Re: Ordinance 09-14 - Rezoning Approximately 27.5 Acres, Located on the North Side of Hard Road and on the West Side of Sawmill Road, from PUD, Planned Unit Development District (NE Quadrant, Subarea 5A) to PUD, Planned Unit Development District (NE Quadrant, Subarea 5A (Amended)) to Modify the Development Text and Preliminary Development Plan Regarding an Addition to the Existing Grocery Store and Modifications to the Permitted and Conditional Uses. (Case 13-084Z/PDP/FDP/CU) (Second reading/public hearing February 10 Council meeting)

13-084Z/PDP/FDP/CU
 Rezoning/Preliminary Development Plan/Conditional Use
 Final Development Plan
 NE Quad - Subarea 5A - Kroger Marketplace
 7625 Sawmill Road

- 1. NE Quad – Subarea 5A – Kroger Marketplace 7625 Sawmill Road**
13-084Z/PDP/FDP/CU Rezoning/Preliminary Development Plan/
Final Development Plan/Conditional Use

SITE PLAN

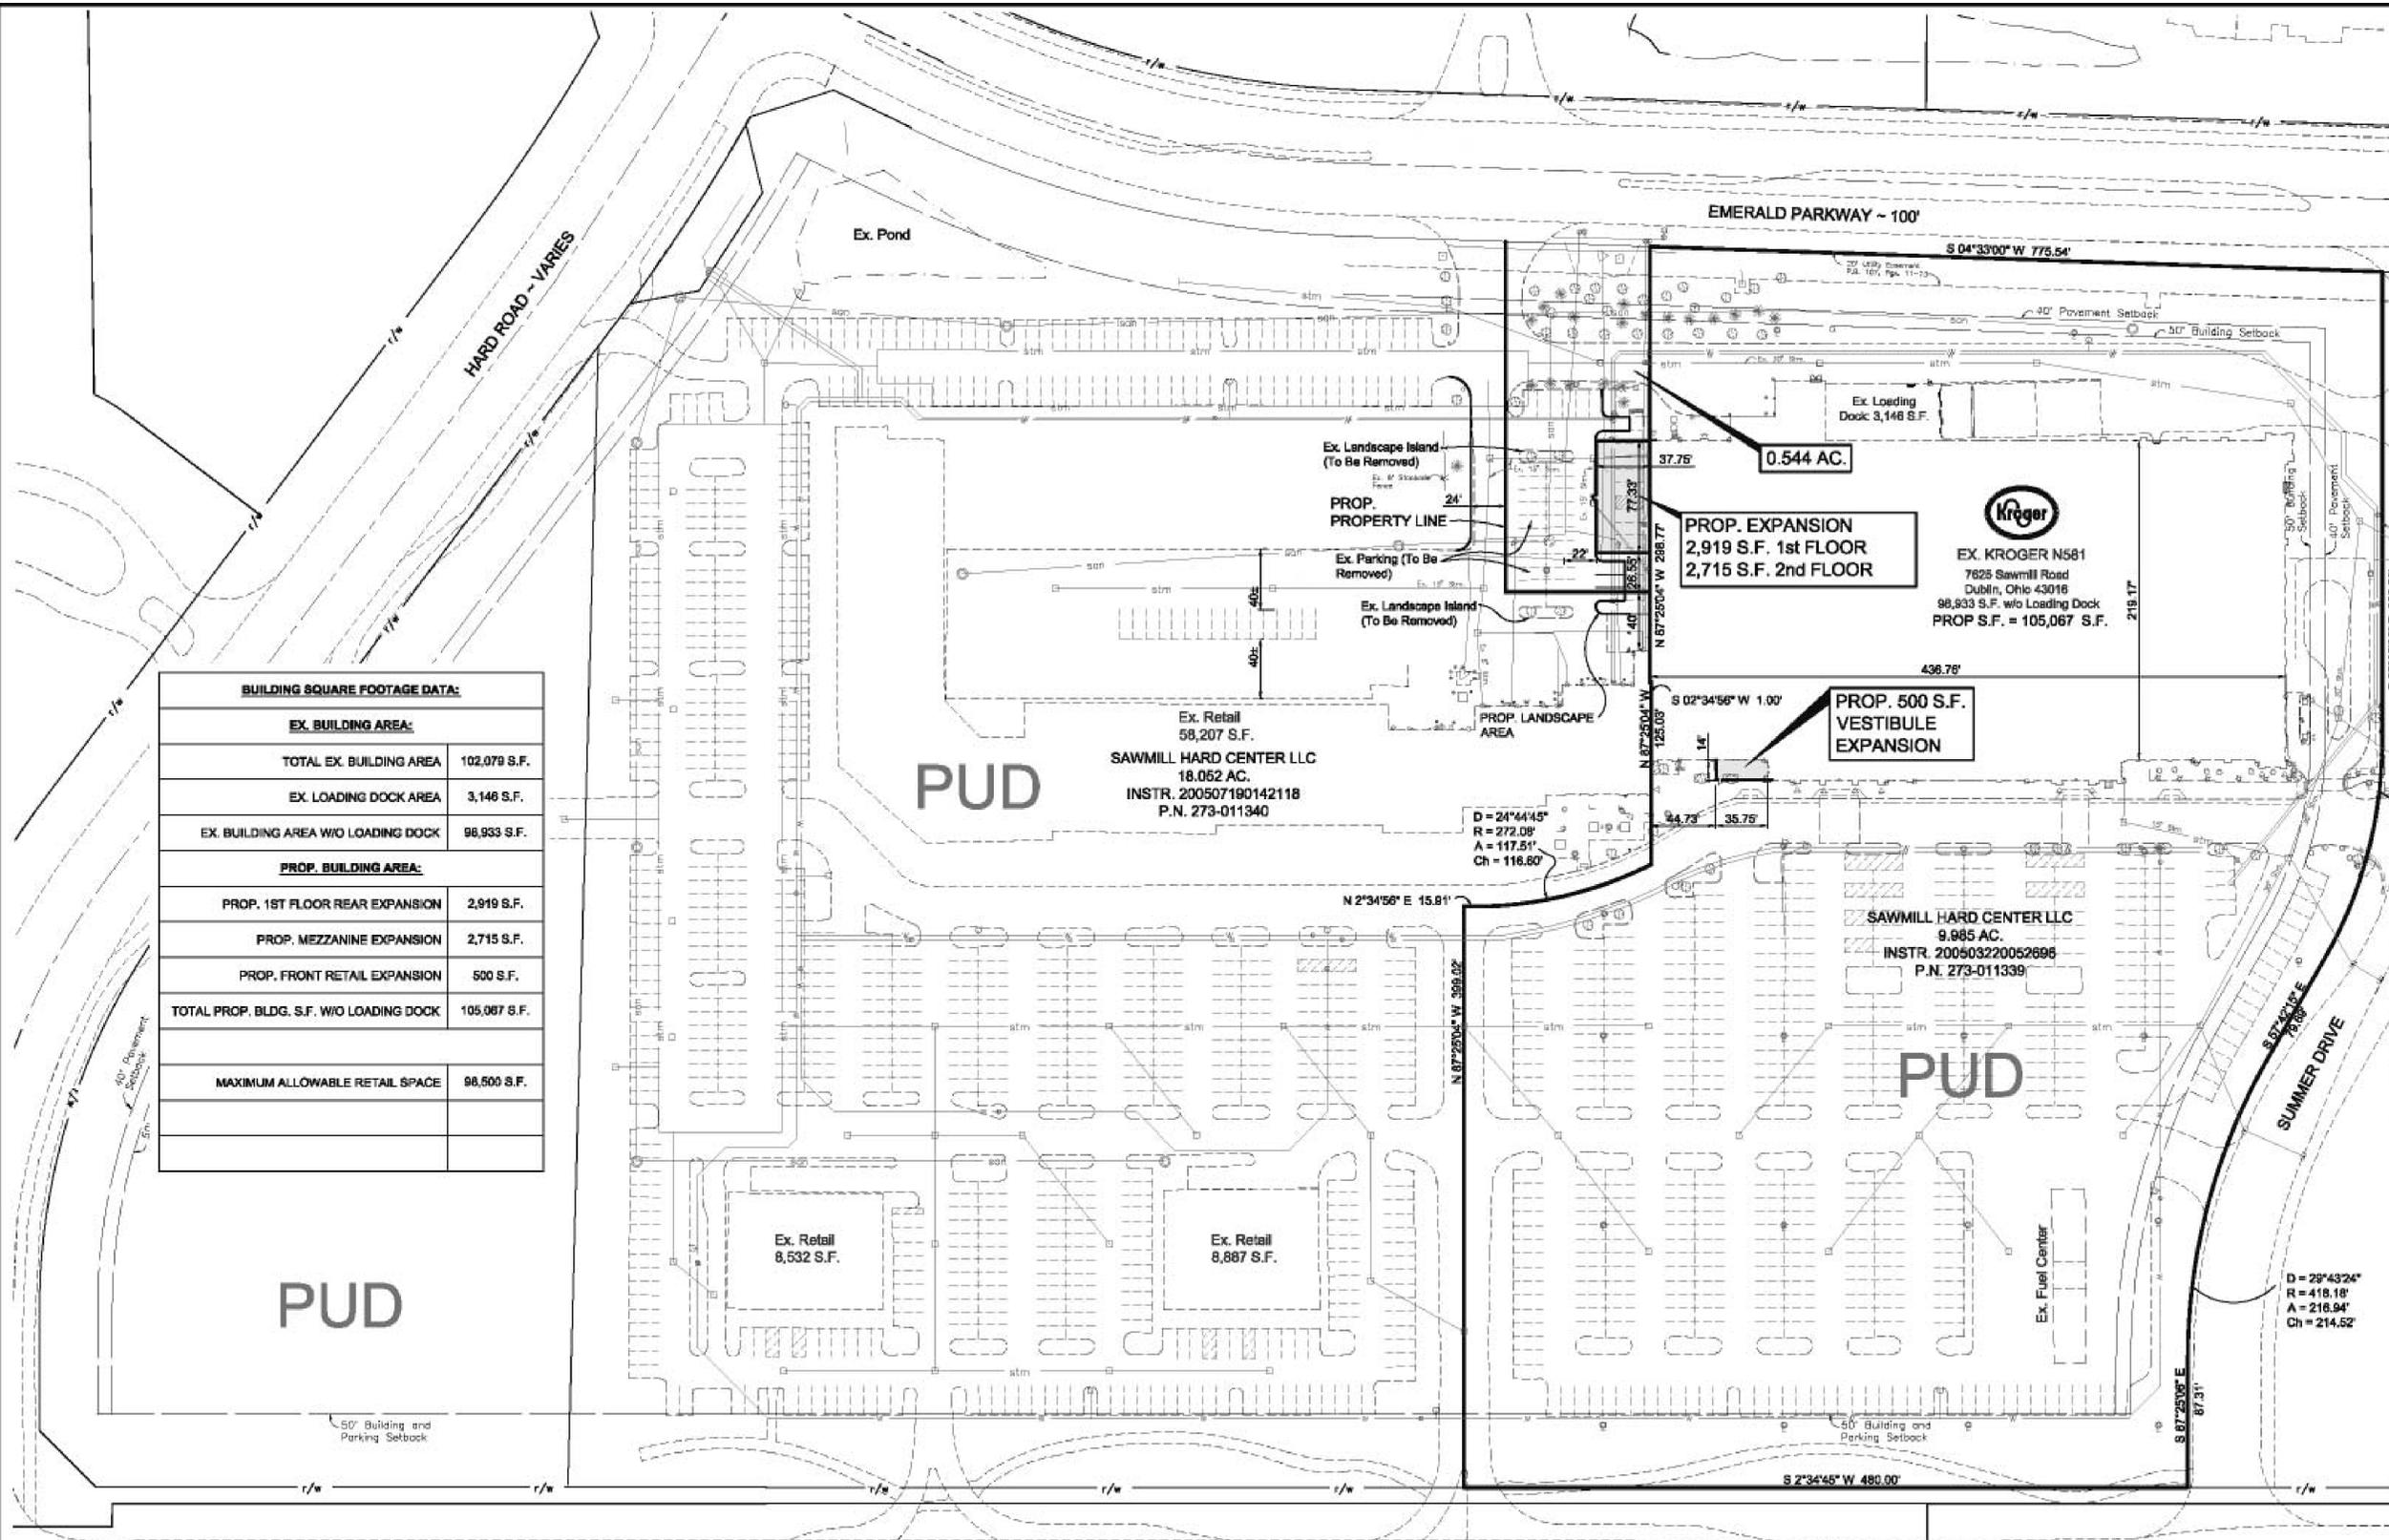
Mr. Hardt said he appreciated the change to the parking in the rear. Mr. Hardt said the proposed modification to limit the retail could seem like a minor concession, but he did not think it was. He said the concern from residents to limit the grocery store to 100,000 square feet to ensure the scale and character of the store and the retail center focused on the neighborhood would be maintained. He said the retail floor space will be held steady, meaning the character and the scale of the store is not changing. He said we are indeed only adding storage and for him that was a significant difference that went a long way toward making him feel comfortable with this proposal.

Richard Taylor said he had no problem with the additional space because it was being designated as storage and office space and does not increase the retail floor size. He thanked the applicant for removing the Starbucks sign. Mr. Taylor recalled on the previous proposal a pharmacy window was being moved and he did not see any reference to that on the plan. He said the floor plan showed the existing window blocked up.

The approved development text requires 1,058 parking spaces for the entire shopping center, including the multi-tenant buildings and fuel center. The proposed addition to the rear would have removed 11 spaces and would need to be replaced. During the Planning and Zoning Commission review, the Commissioners did not want to add more parking to replace these spaces because of the number of unused spaces already on the site. Accordingly, the applicant has modified the text to reduce the total number of required parking spaces to 1,047.

2. There shall be ~~1,058~~1,047 parking spaces provided for Subarea 5A including the multi-tenant retail building and gasoline sales area, as indicated on the site plan. Eight stacking spaces shall be provided for the pharmacy drive-thru as part of the grocery. The applicant has planned this development around the preservation of the 4.4 +/- acre tree preservation zone at the northwest corner of Hard and Sawmill Roads. Also, the City of Dublin realigned the Emerald Parkway extension easterly resulting in a net loss to this property of approximately two (2) acres. Due to the provision of the 4.4 +/- acre tree preservation area and the acreage loss due to the road realignment, this site does not meet the minimum parking requirement. In consideration of these factors, the minimum parking requirement shall not be strictly enforced.

FRONT ELEVATION - EAST
ALL PROPOSED MATERIALS AND SIGNAGE ARE TO MATCH EXISTING UNLESS NOTED OTHERWISE

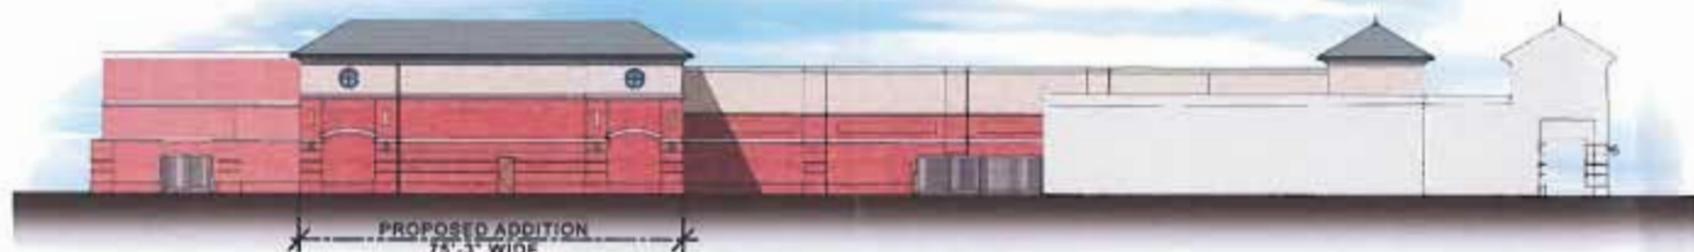
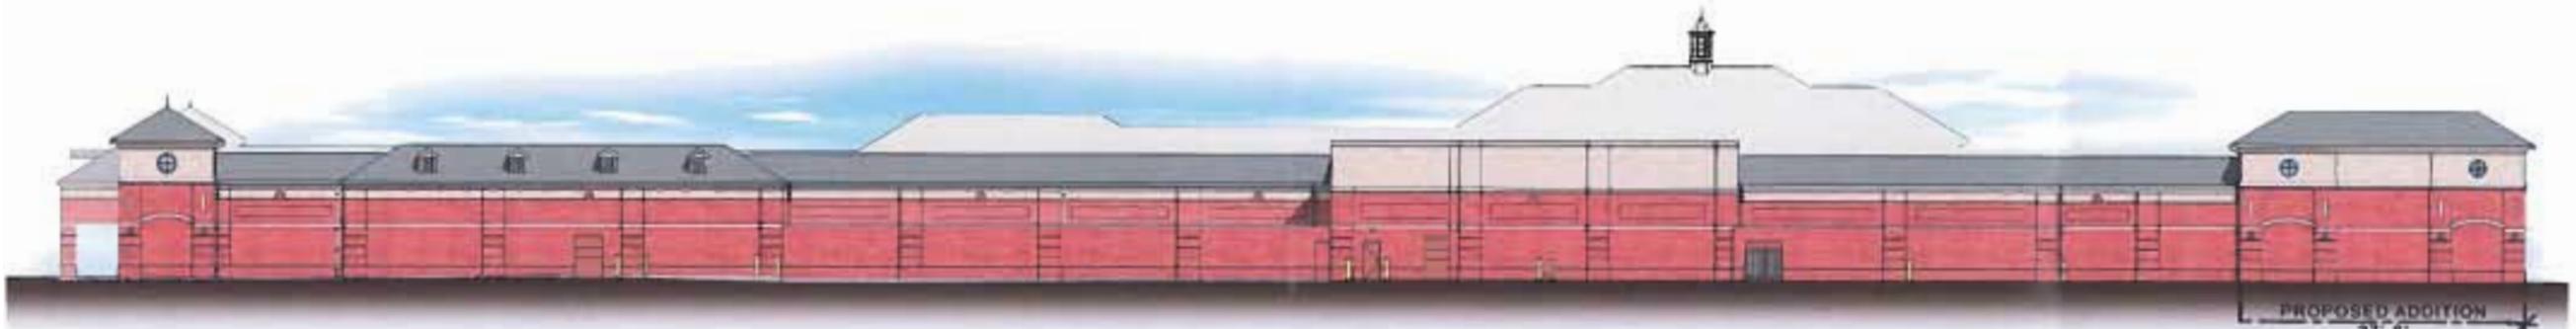
Ms. Rauch said the proposed Final Development Plan includes modifications to the architecture which are compatible with the existing building design and materials. She presented the plan showing the area where the building additions will be located. She said the existing trees located along the front elevation will be removed with the construction and have been conditioned to be replaced on site per Code. Ms. Rauch said the rear addition will require the removal of existing parking spaces. She said the previous proposal included the replacement of these spaces on site; however, the Commission determined these spaces would not need to be replaced because of the over-parked nature of this site. She said to address this comment the applicant has reduced the required parking number within the development text.

Mr. Hardt said during the previous review the rear elevations and the floor plan did not match and wanted to confirm these discrepancies had been addressed. Mr. Hale said it had been and there was only one round window.
